DRG SUBMITTAL
G0.1
 Plotted On: 5/26/22

COVER SHEET

2 CABIN 5 & 6 EXISTING-DEMO FIRST FLOOR PLAN
SCALE: 1/4" = 1'-0"

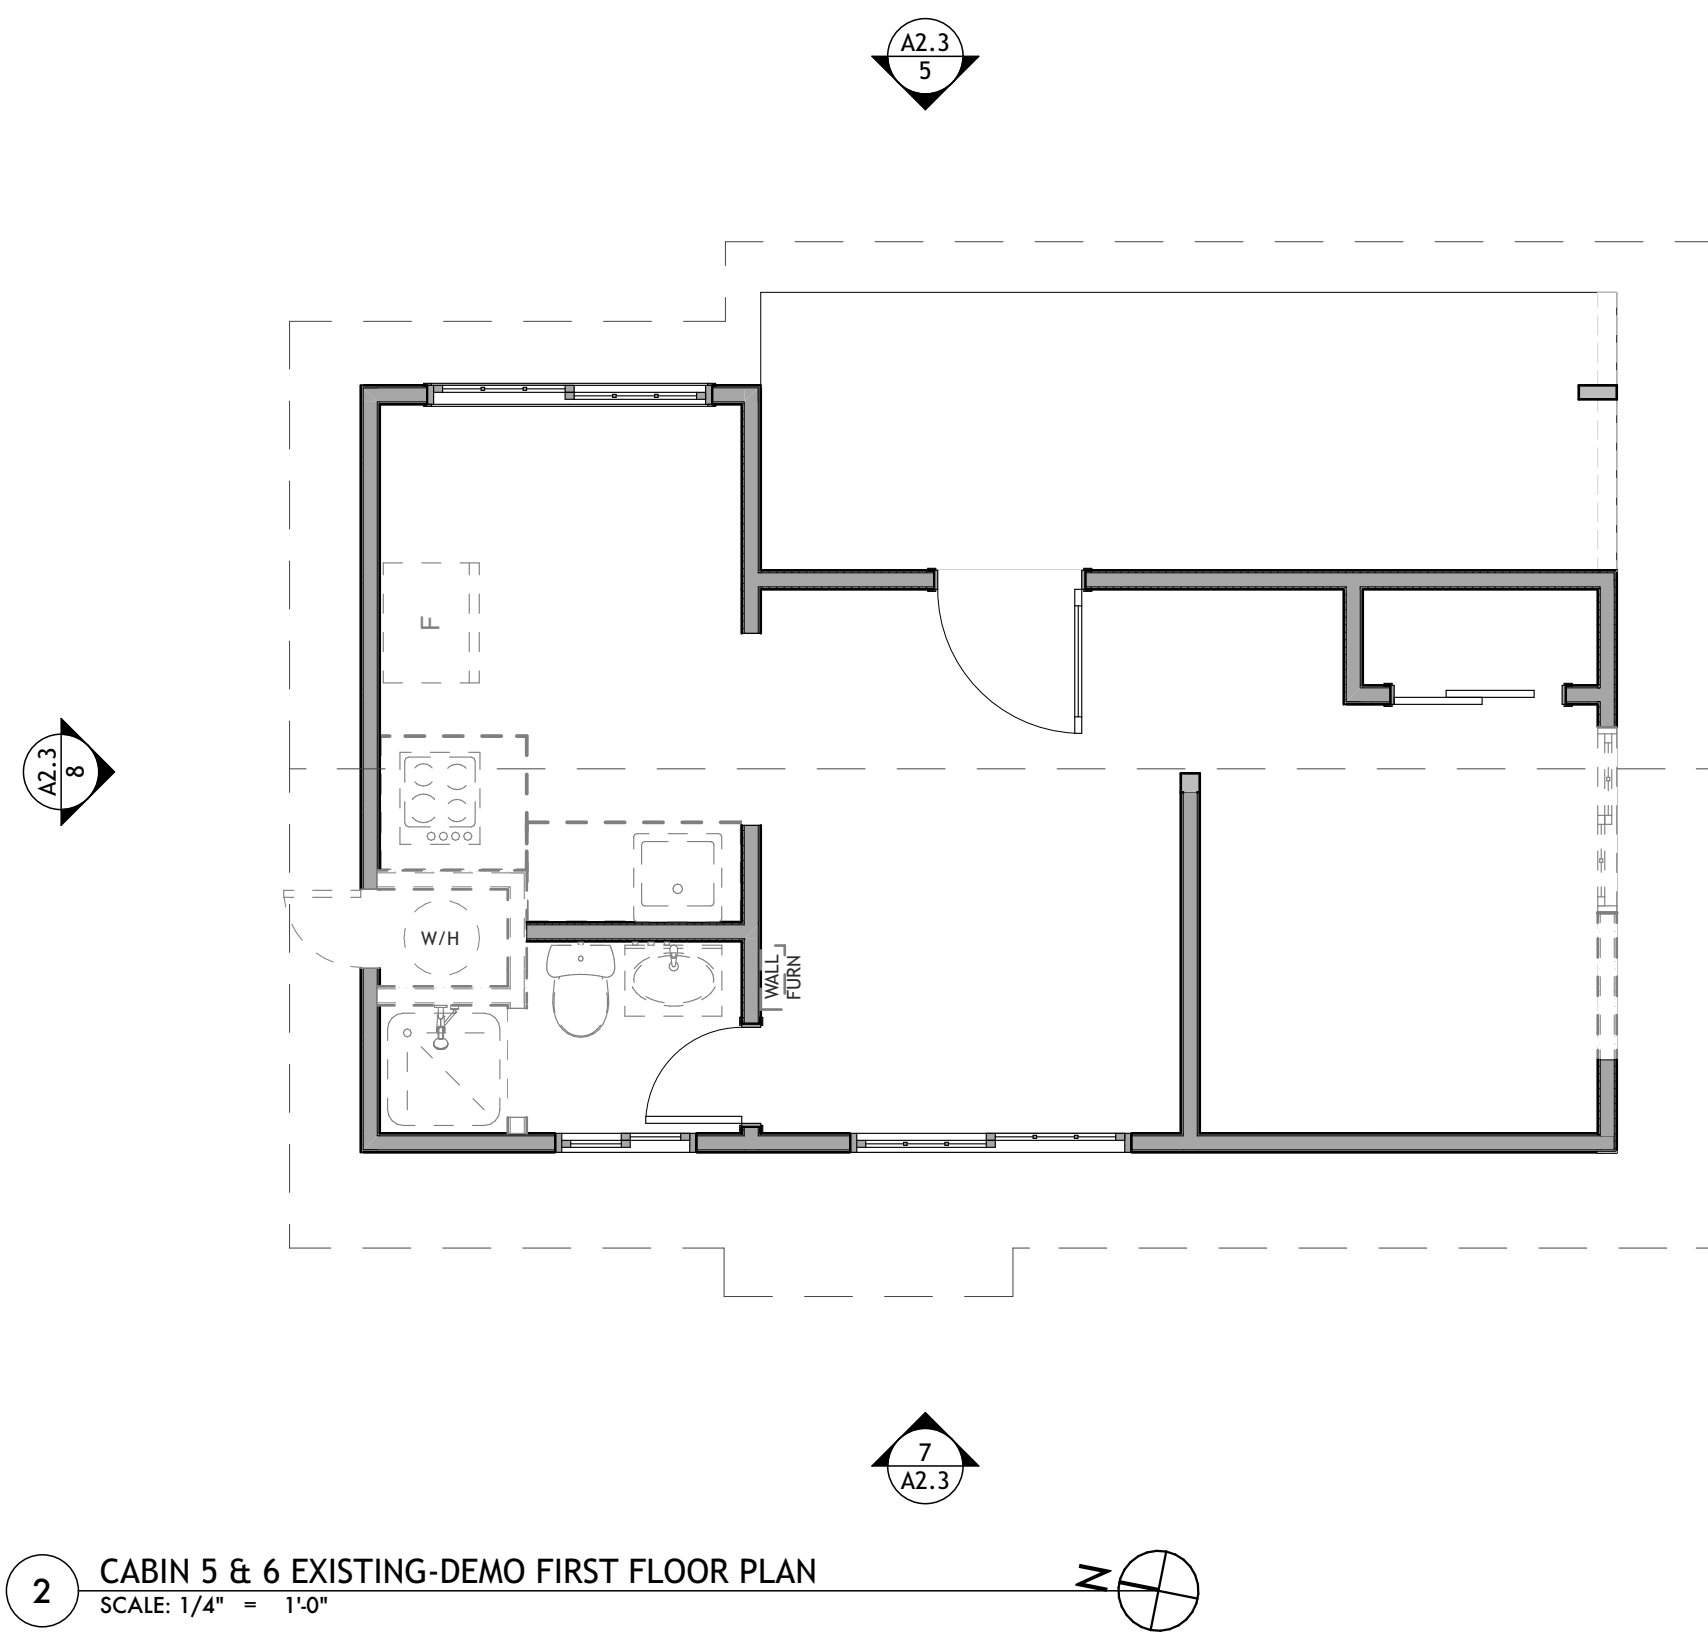
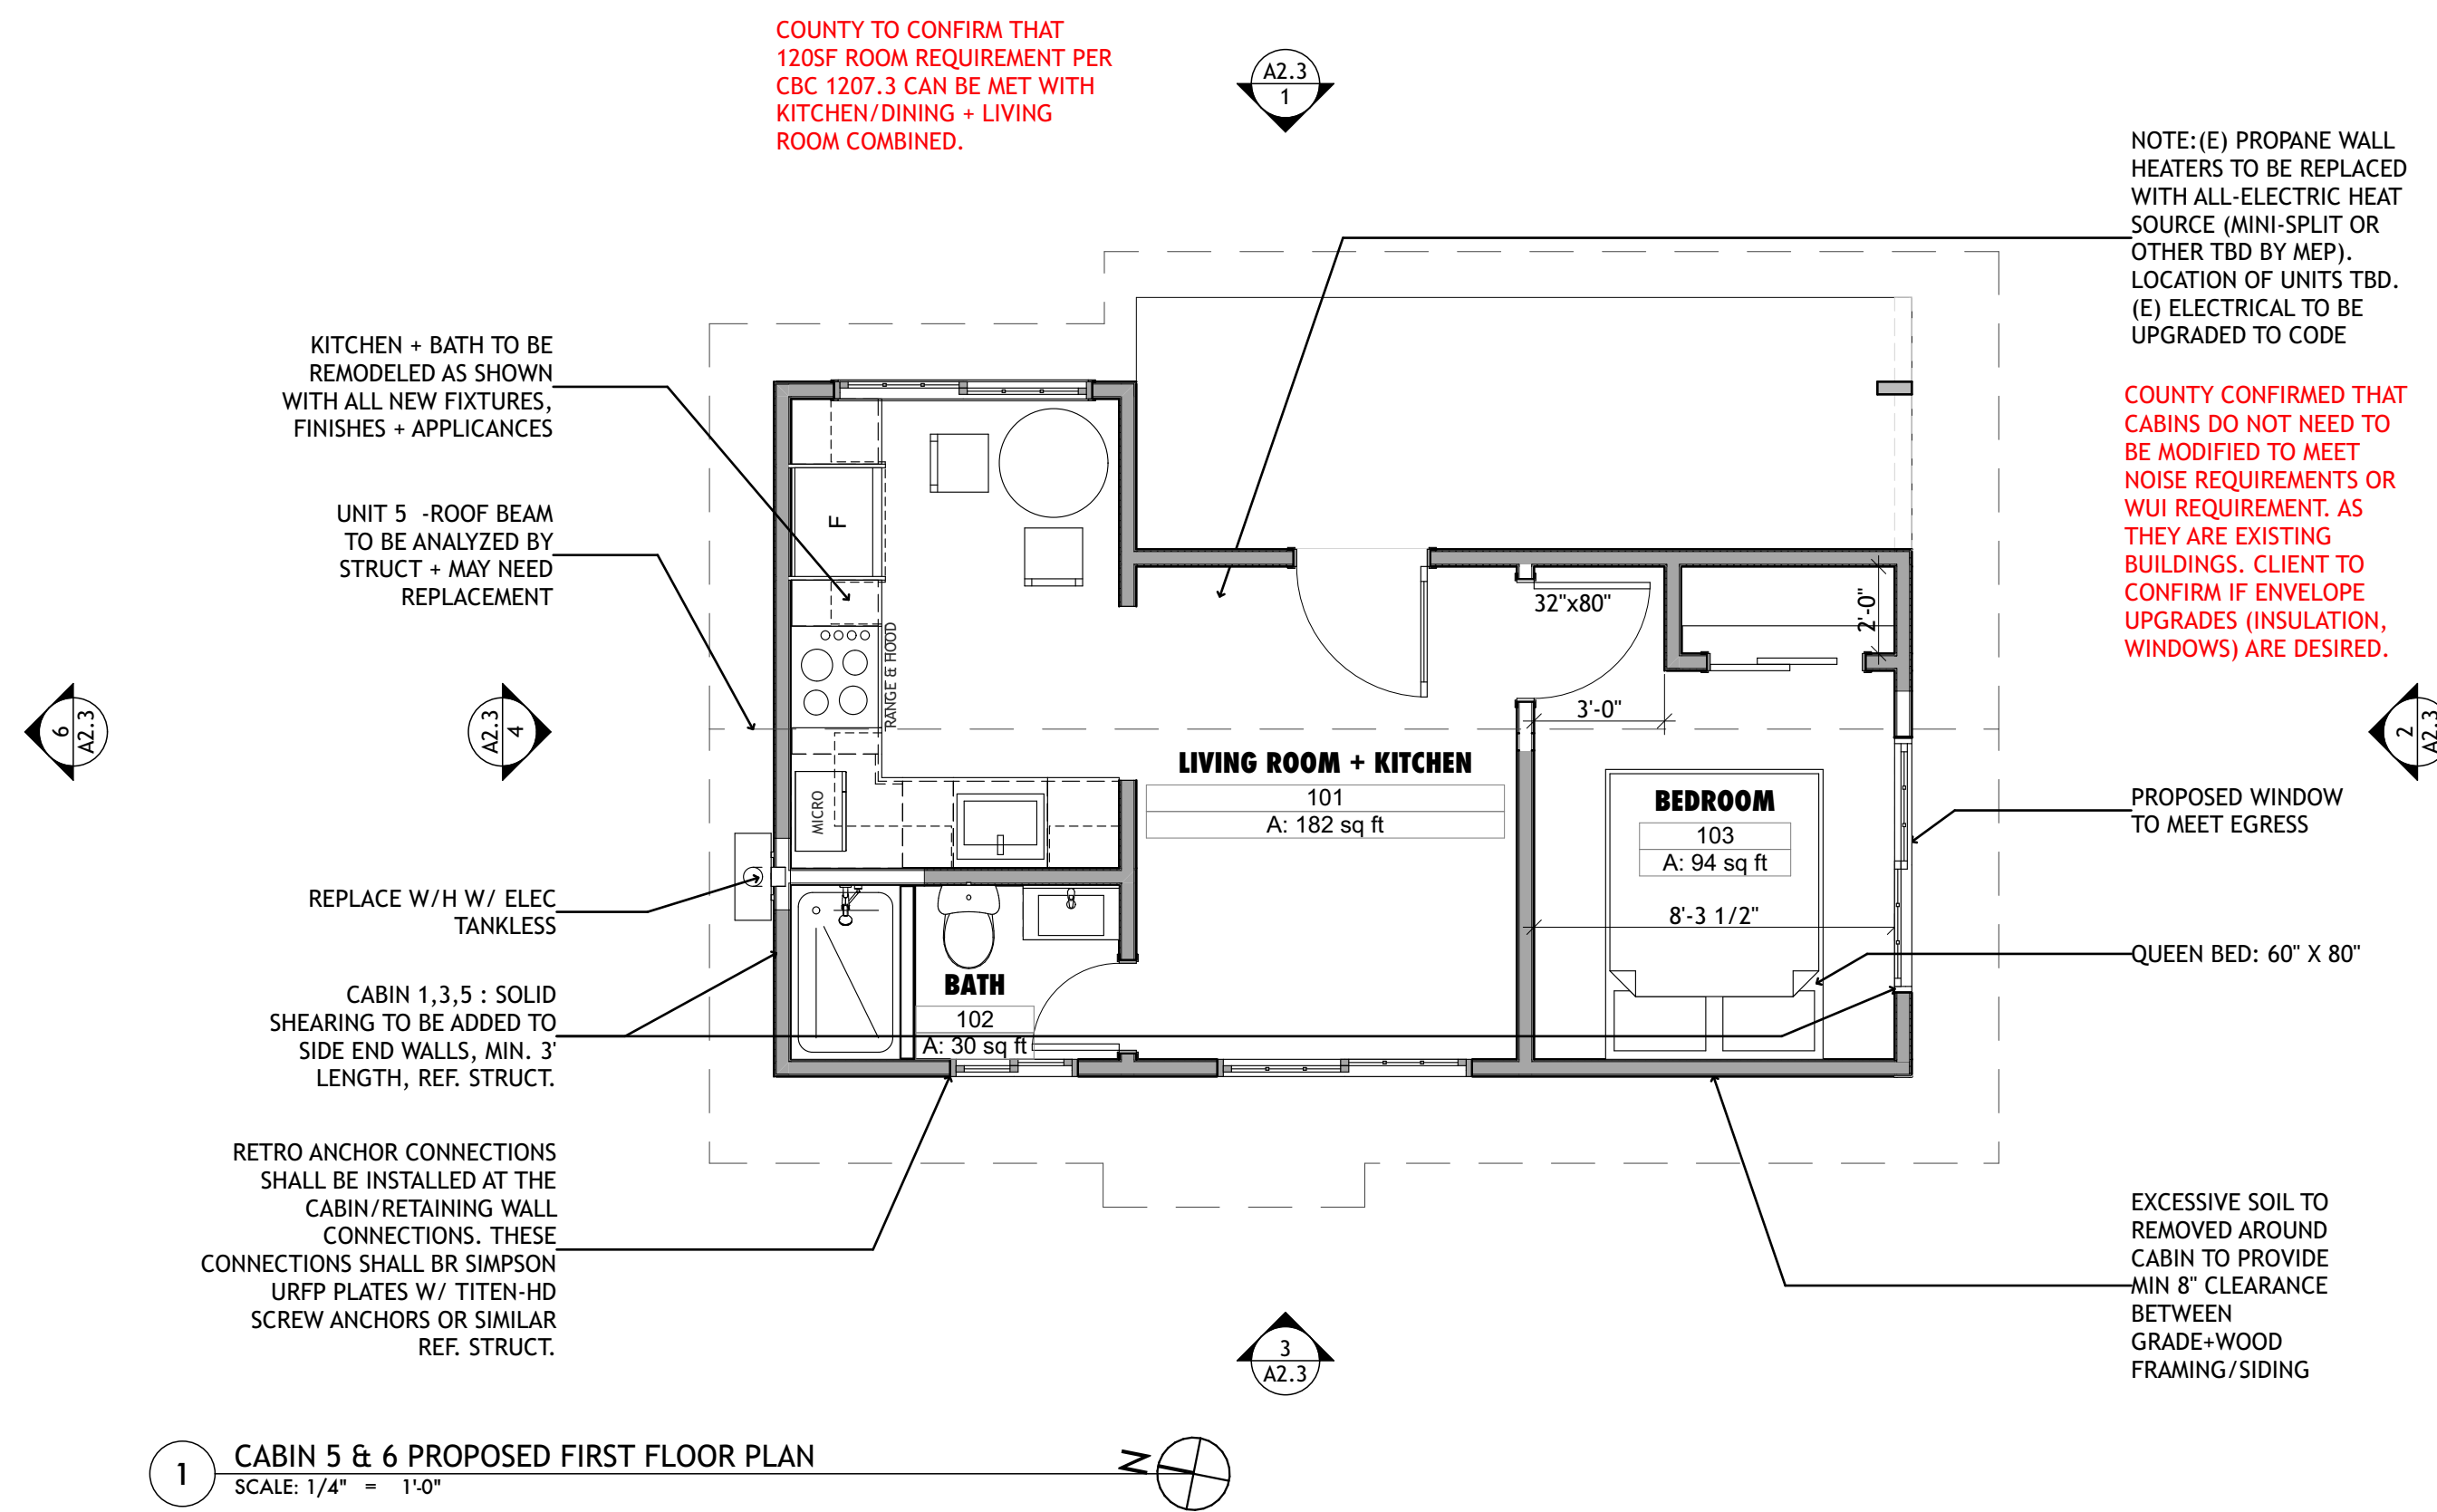
NOTE:(E) PROPANE WALL HEATERS TO BE REPLACED WITH ALL-ELECTRIC HEAT SOURCE (MINI-SPLIT OR OTHER TBD BY MEP), LOCATION OF UNITS TBD. (E) ELECTRICAL TO BE UPGRADED TO CODE

COUNTY CONFIRMED THAT CABINS DO NOT NEED TO BE MODIFIED TO MEET NOISE REQUIREMENTS OR WUI REQUIREMENT, AS THEY ARE EXISTING BUILDINGS. CLIENT TO CONFIRM IF ENVELOPE UPGRADES (INSULATION, WINDOWS) ARE DESIRED.

REPLACE W/H W/ ELEC. TANKLESS

CABIN 1,3,5 - SOLID SHEARING TO BE ADDED TO SIDE END WALLS, MIN. 3' LENGTH, REF. STRUCT.

EXCESSIVE SOIL TO BE REMOVED AROUND CABIN TO PROVIDE MIN 8" CLEARANCE BETWEEN GRADE+WOOD FRAMING/SIDING
